ADDENDUM NO. 2

DATE: February 24, 2023

RE: Dickinson Park Sports Fields Renovations
Project No.: 21-1558

Drawings: (all revisions have been clouded and tagged with a delta-2)

O:\Projects\2021\21-1558 Dickinson Park Ball Field Renovations\CAD\Arch_Revit

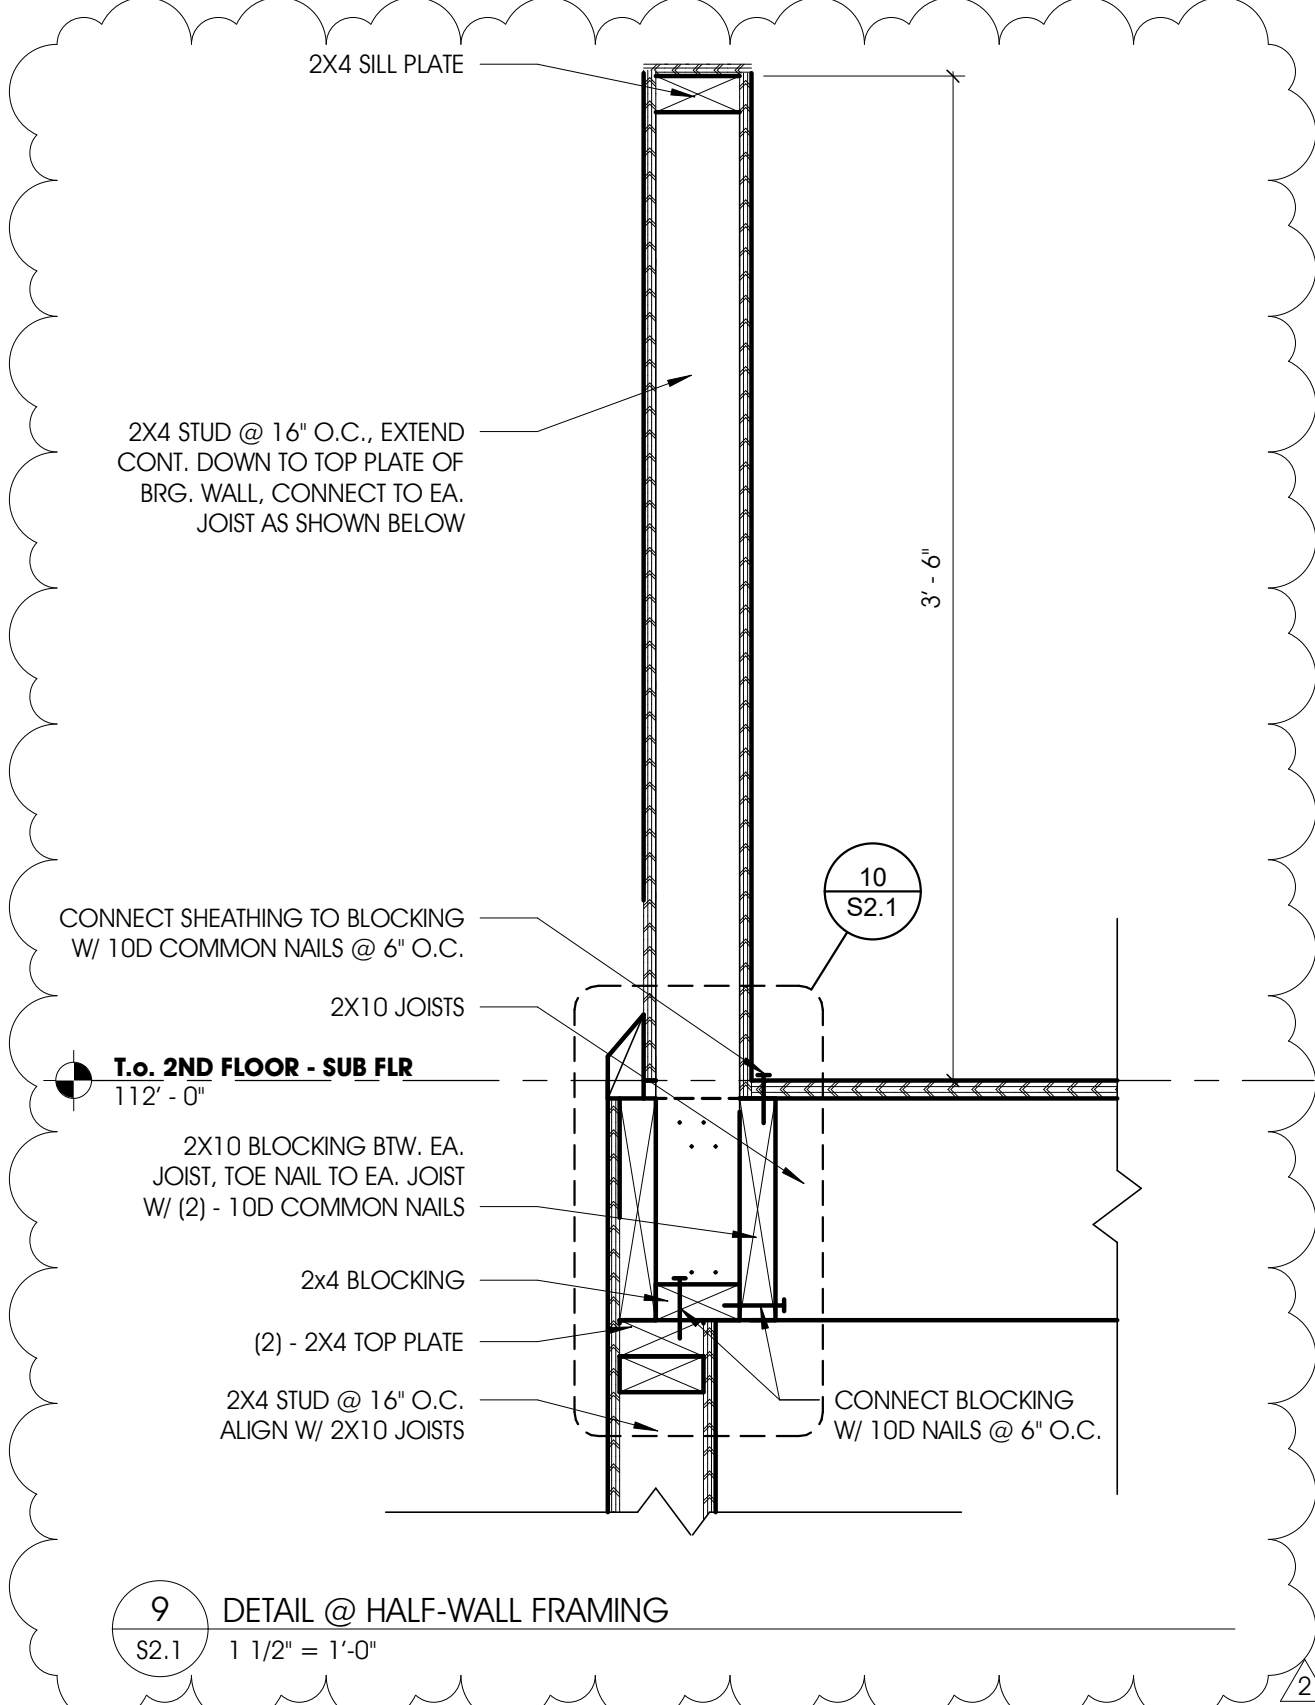
- d. Added Lintel Sections detail drawings.
 - e. Minor revisions to General Notes C and F.
13. Alternate 1, Sheet S2.1
- a. Added Sheet S2.1; previously omitted by error

- b. Added top of CUM Wall, Roof Rafter tie-down/anchoring details (drawings 2/S2.1, 3/S2.1, 5/S2.1, 6/S2.1)
 - c. Added Ledger Detail (drawing 8/S2.1)

- d. Added Detail @ Half-Wall Framing (drawings 9/S2.1 and 10/S2.1)
14. Alternate 1, Sheet A1.1
- a. Revised dimension string in drawing 2/A1.1 (see revision bubble)

3 STAIR SECTION 2
A3.3 3/8" = 1'-0"

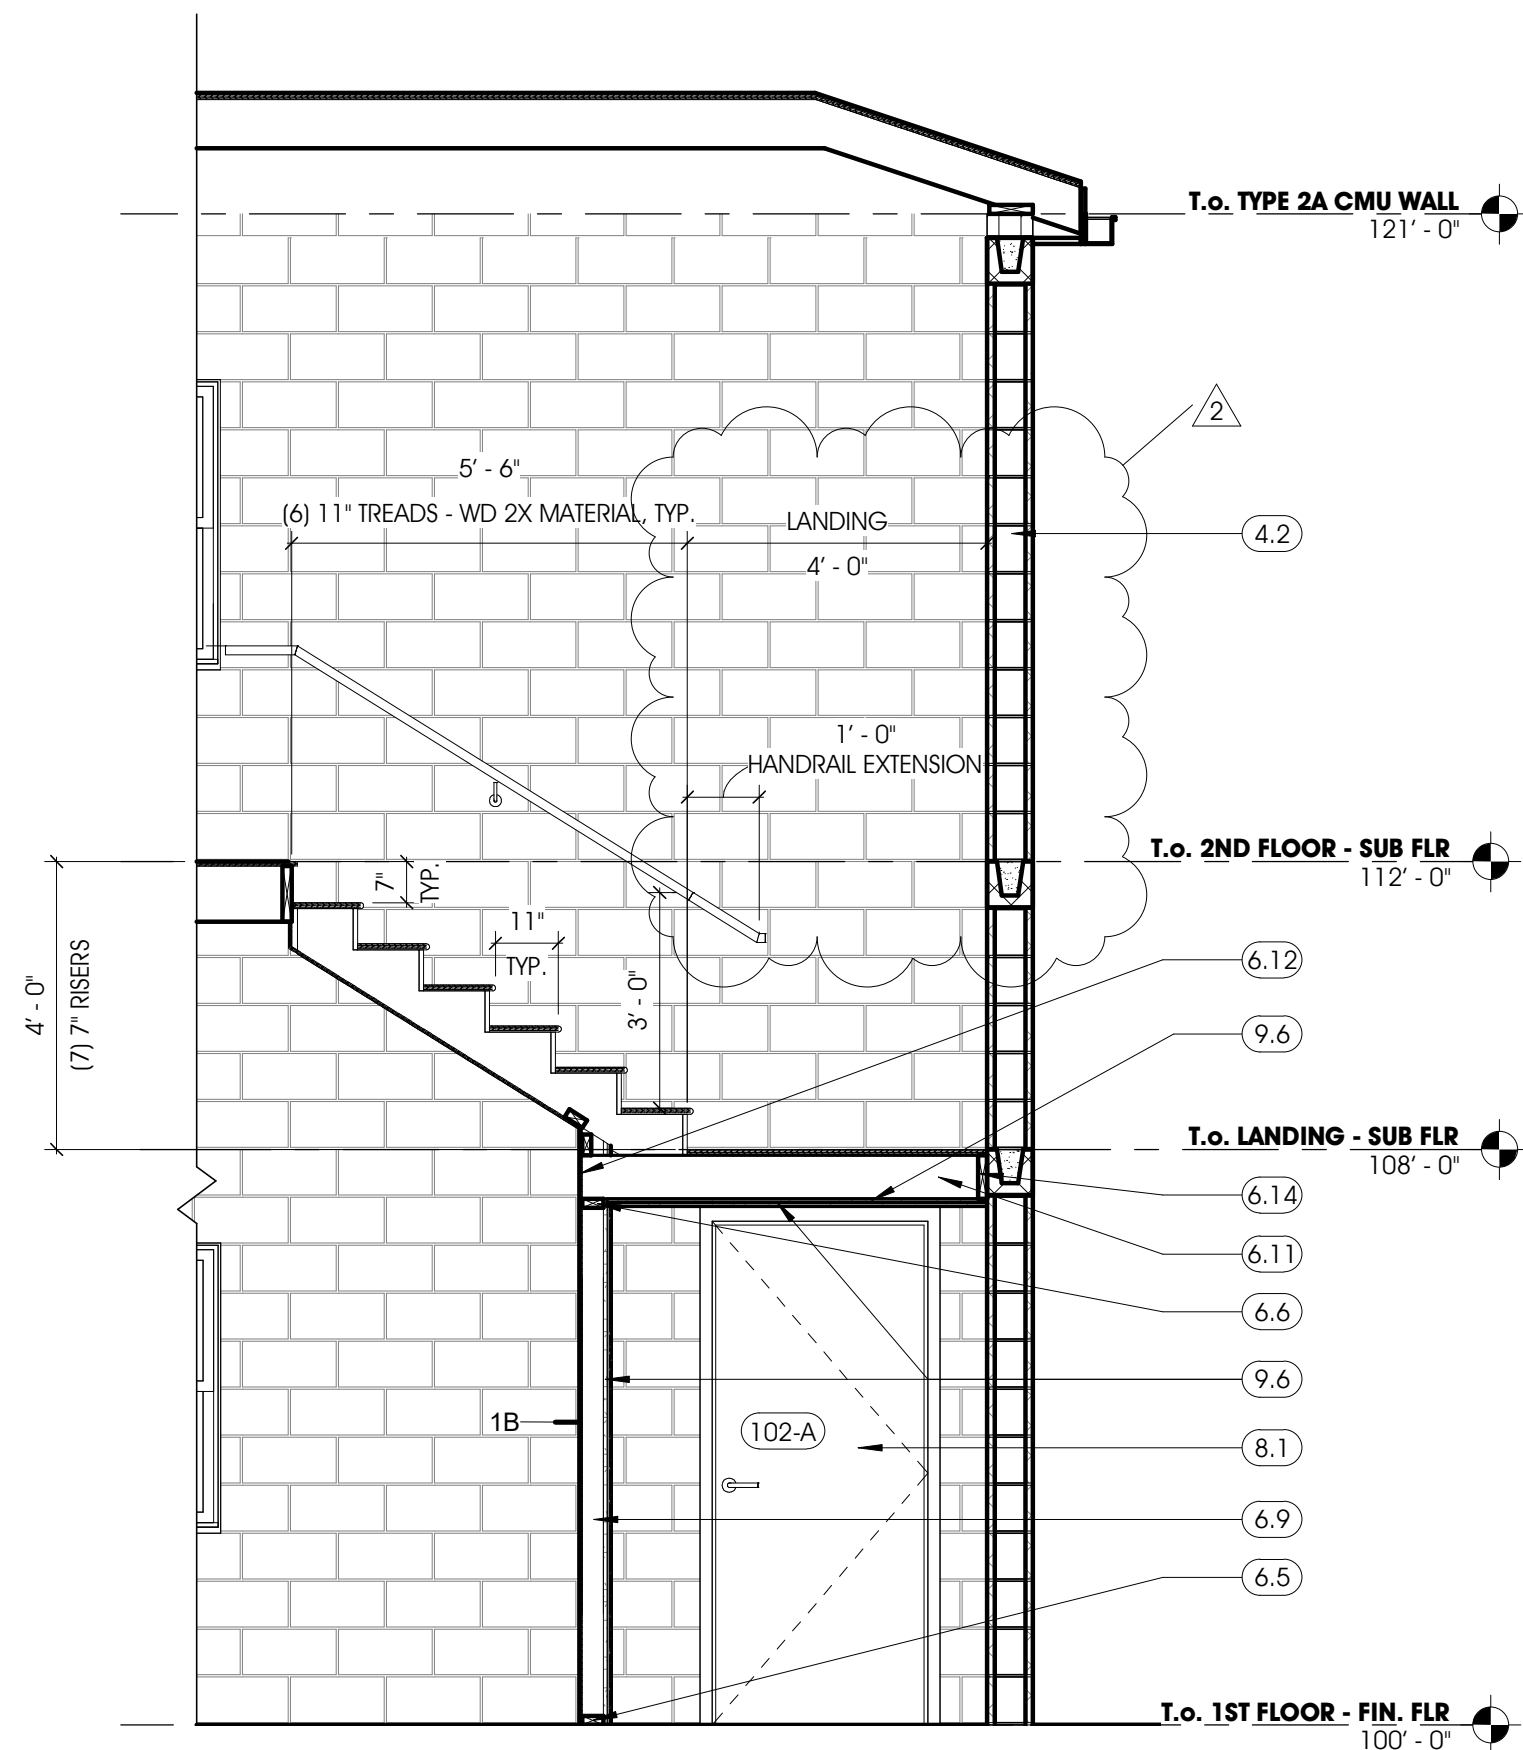
15. Alternate 1, Sheet A3.3
- a. Revised landing width and handrail extension dimensions, respectively, in drawing 3/A3.3 (see revision bubble)
 - b. Revised handrail extension(s) to show handrail(s) return to wall at top of stair location in drawing 1/A3.3 (see revision bubble)

1 ENLARGED STAIR PLAN
A3.3 3/4" = 1'-0"

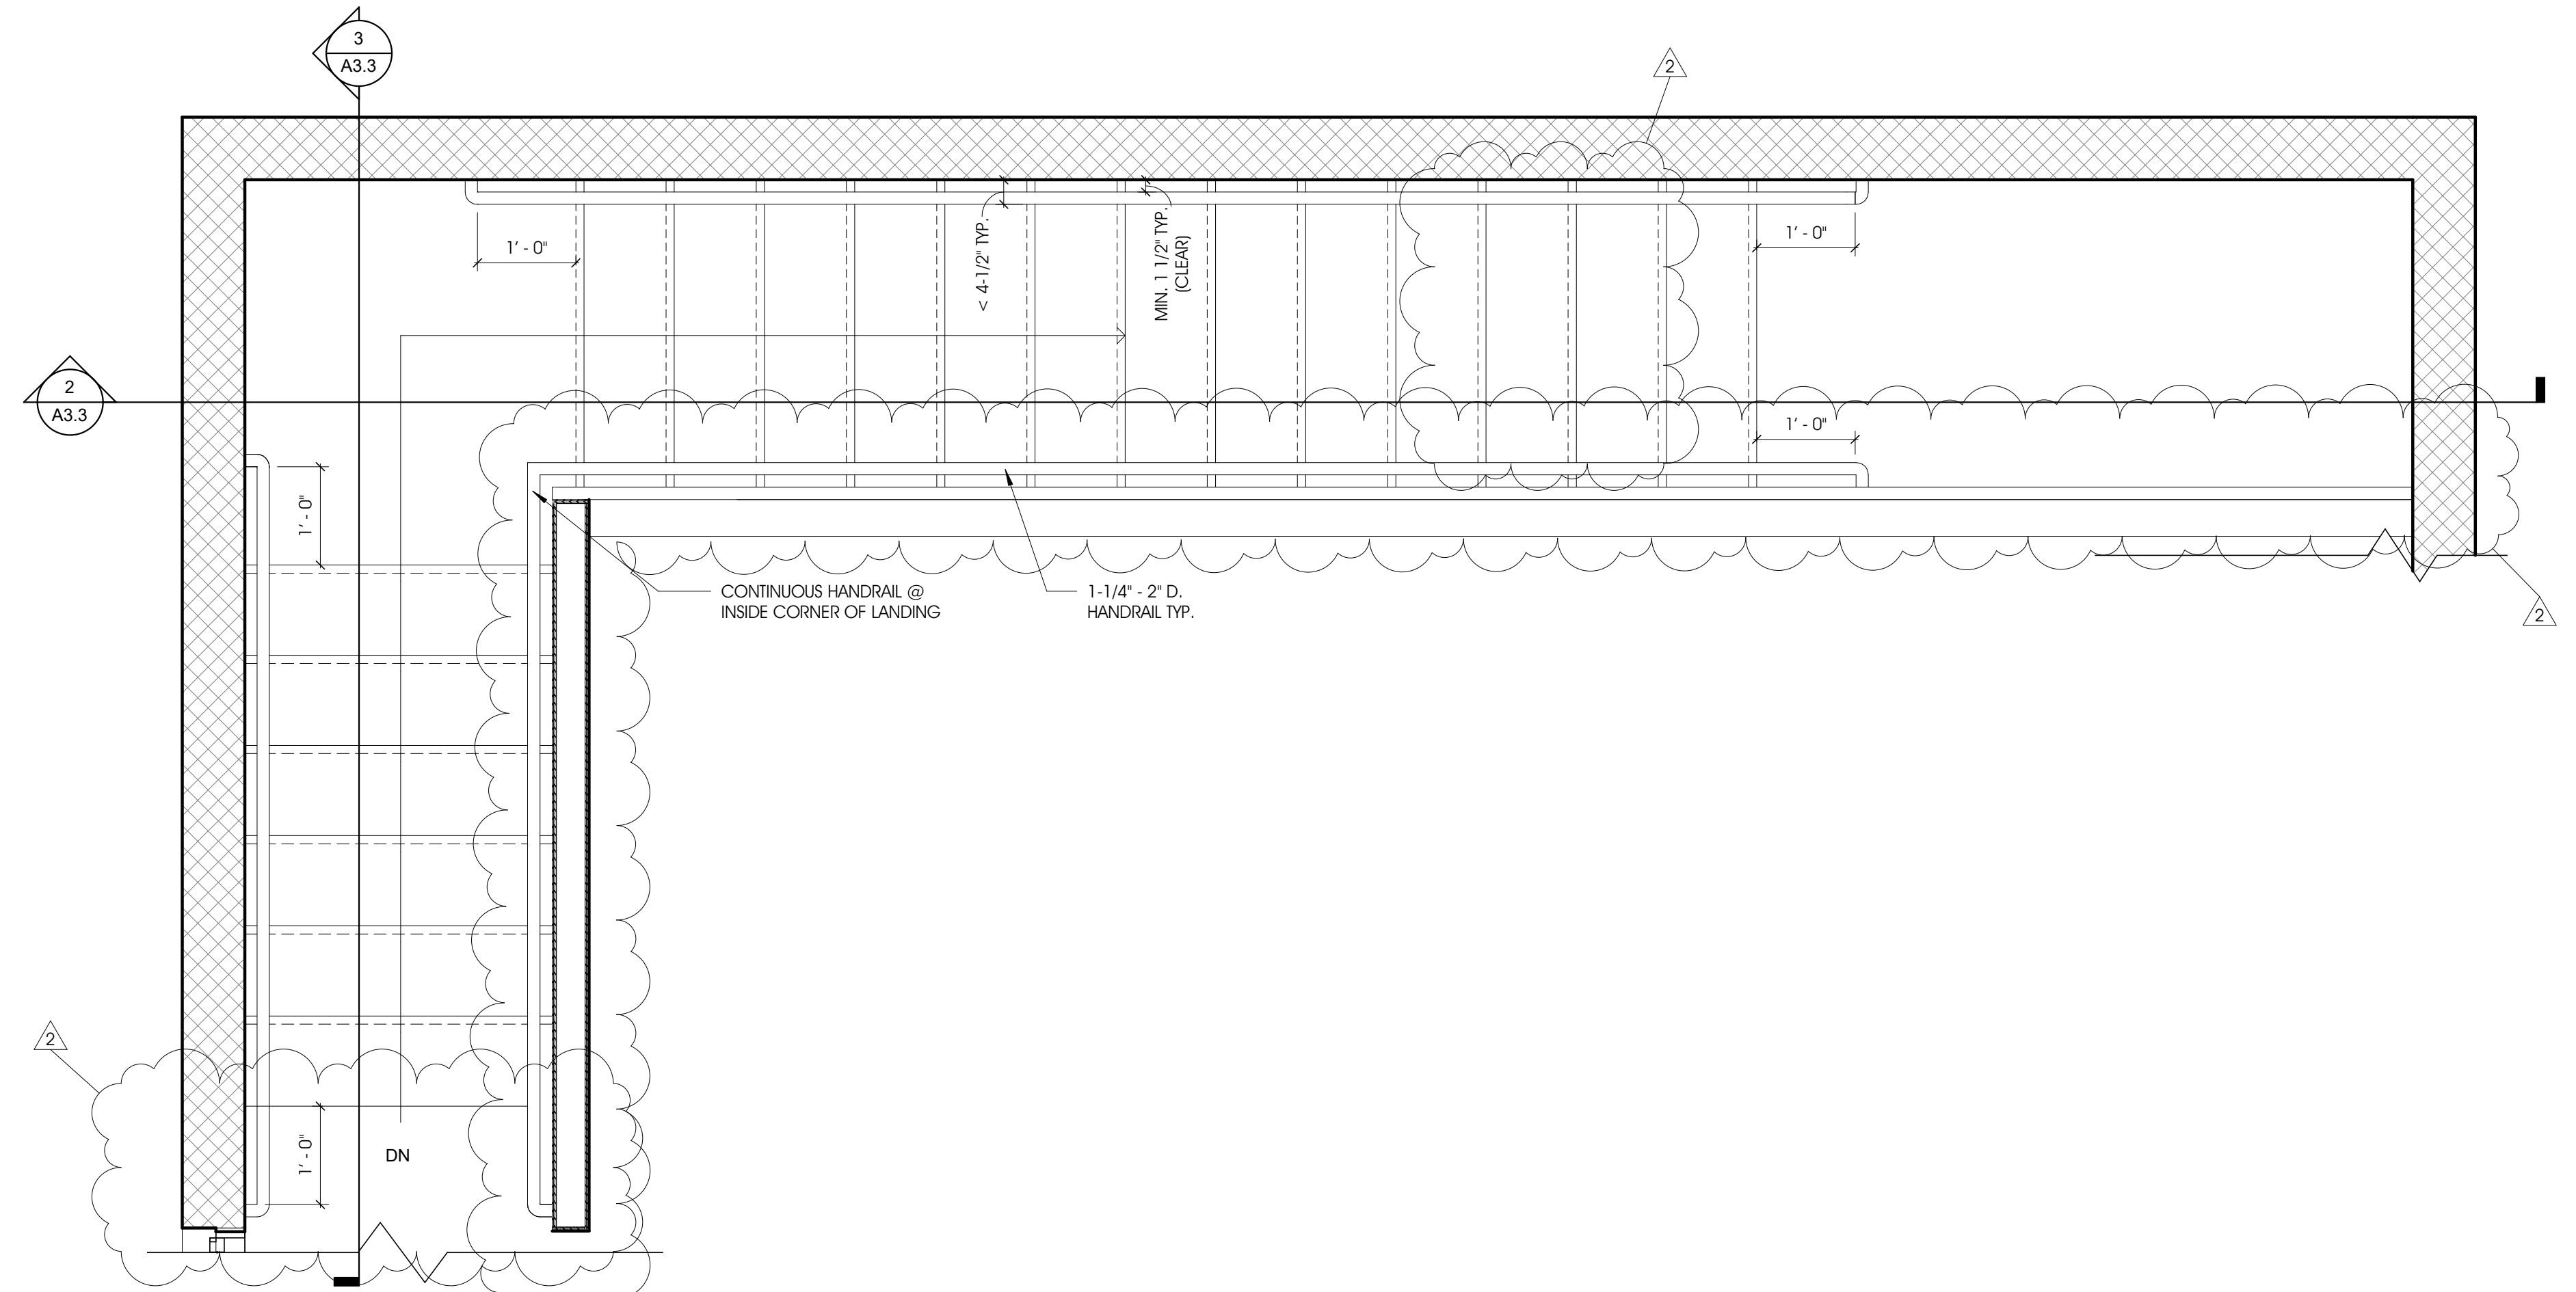
- c. Revised 2nd floor interior wall(s) linework to accurately portray the east-west 42" tall Half-Wall and north-south full-height wall in drawing 1/A3.3 (see revision bubble)

- d. Removed dimensions from 1/A3.3 regarding stair width that are already identified on drawings 1/A1.1 and 2/A1.1 (see revision bubble)
16. Alternate 1, Sheet A8.1
